SERVICE BULLETIN NO. SB-08-131

**SUBJECT: ArvinMeritor – Technical Bulletin – Safety Recall:
Lower Axle Seat Weld Inspection and Repair for Meritor RideSentry™**

Lower Axle Seat Weld Inspection and Repair for Meritor RideSentry™ MPA Series Sliding Tandem Trailer Air Suspension Systems

Figure 1

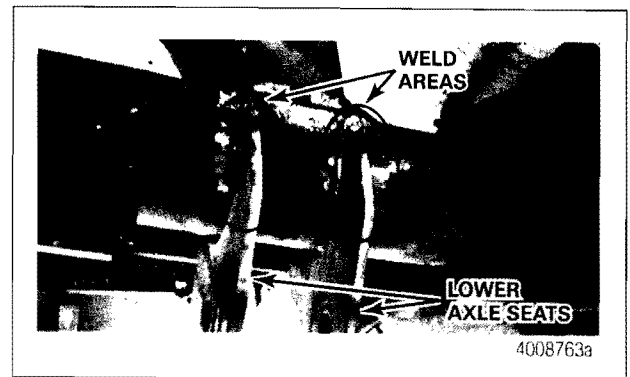
1. Wear safe eye protection. Park the vehicle on a level surface. Block the wheels to prevent the vehicle from moving.
2. From underneath the trailer, inspect the lower axle seat welds as follows.
 - A. Check that there are a total of four welds per axle seat side (two lower axle seats welded on each side). Figure 1.
 - B. Verify the welds are nominally 1.5-inches (38 mm) long and 0.25-inch (6.35 mm) wide on each side of the lower axle seat onto the axle. The welds should not be more than 1.5-inches (38 mm) long. Figure 2.

- If any welds are missing or incomplete: Call ArvinMeritor's OnTrac Customer Service Center at 866-OnTrac1 (668-7221) for repair authorization. Refer to Contact the ArvinMeritor OnTrac Customer Service Center at the end of this bulletin. Once you receive authorization, perform the Weld Repair Procedure in this bulletin.

1. Wear appropriate clothing and eye protection when using welding equipment. Refer to Maintenance Manual 8 for complete welding instructions.
2. Use 0.035 E70 wire and 75/25 gas to weld the missing or incomplete areas. Make each weld 1.5-inches (38 mm) long and 0.25-inch (6.35 mm) wide. Welds should not be longer than 1.5-inches (38 mm). Do not weld over the end of the lower seats. Figure 2.
3. When you have finished, verify there is a total of eight complete welds, (two lower axle seats welded on each side). Continue repairs on the other end of the axle, if necessary.
